Amendments to the Drawing Figures

REPLY

Annotated Marked-Up Drawings
10/787,282

FIG 1

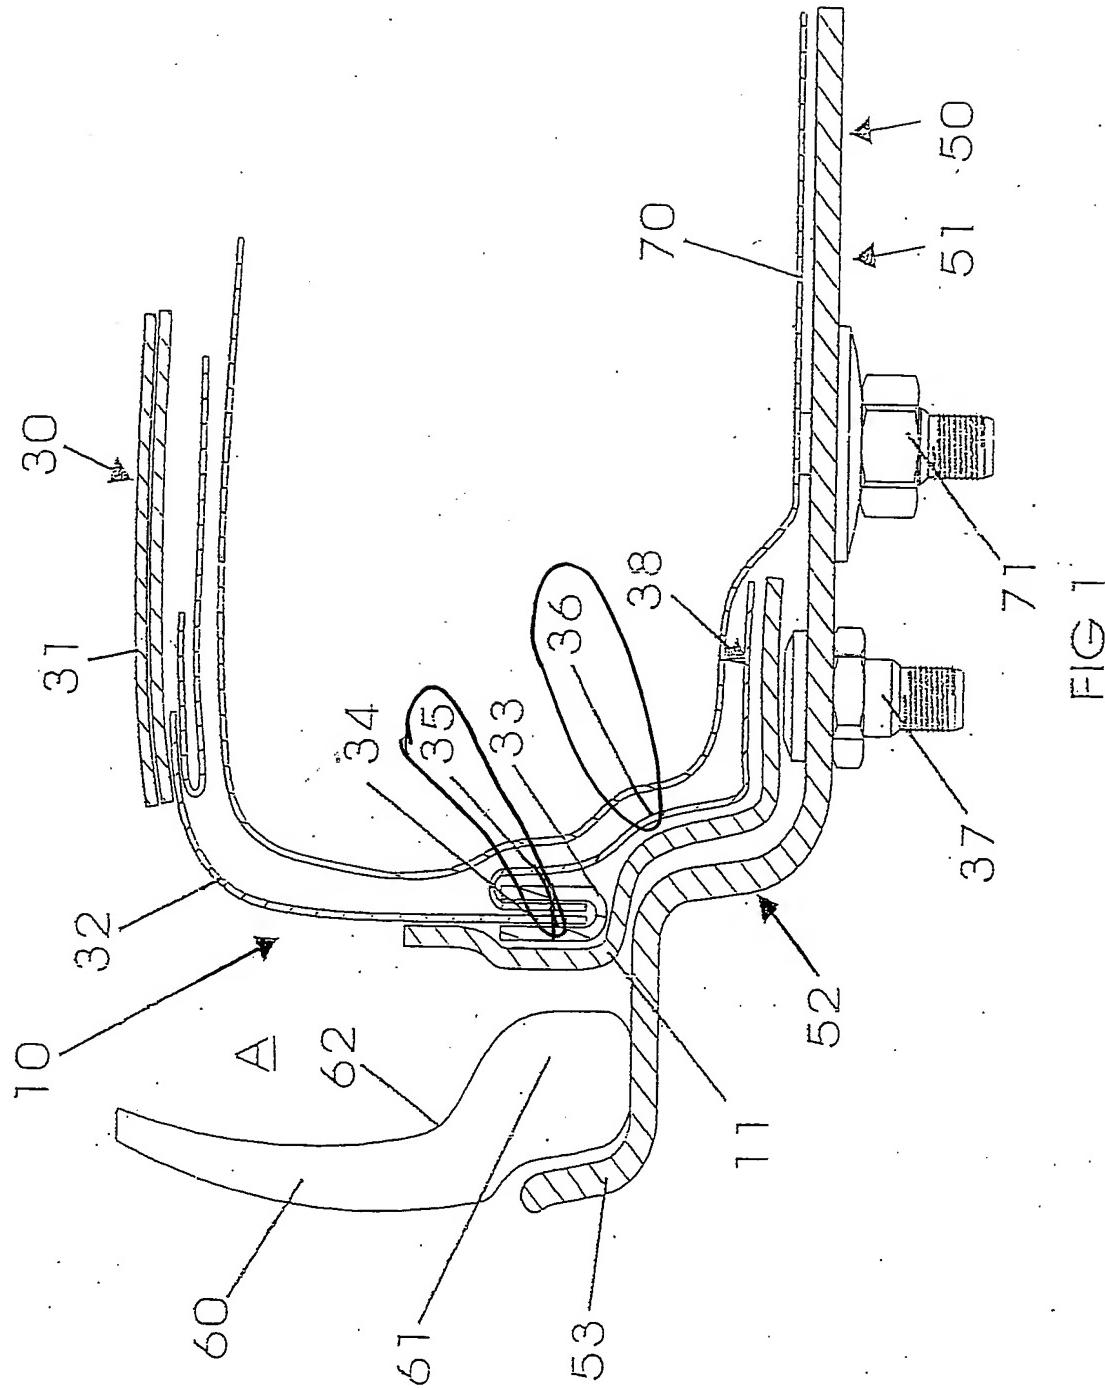
Enclosed are a Replacement Sheet and Annotated Marked-Up Drawing for Fig. 1. The lead lines for elements 35 and 36 have been extended.

The Examiner objected to the drawings because the lead lines in the reference characters 35 and 36 in Fig. 1 point to the wrong element. **Enclosed** with this Amendment and Reply is a Replacement Sheet that corrects the lead lines on reference characters 35 and 36 in Fig. 1 to point to the correct element. For clarity, the stitching 35 has been included in Fig. 1. Support for including the stitching 35 in Fig. 1 can be found on page 8, lines 5-14 of the specification, and illustrated in Fig. 3. Additionally **enclosed** with this Amendment and Reply is a Replacement Sheet for Fig. 3 that more clearly labels the stitching 35.

The Examiner also objected to the drawings, indicating that the insertion bead 33 adapted to push against the tire bead as set forth in claims 1 and 16 must be shown or the feature canceled from the claims. It is respectfully submitted that this feature is shown or illustrated in Fig. 1. The insert bead 33 is attached to sidewalls 32 which are permitted to expand or move axially when the inner tube 70 is inflated. Accordingly, the insert bead 33 is forced axially toward the tire bead 61 so as to push up against it. The elements claimed are shown in the drawings. The operation of the invention, including the insert

bead 33 being pushed against the tire bead 61 during implementation of the invention, is clearly described and appreciated in view of the specification. Therefore, no further drawing amendment is believed to be necessary.
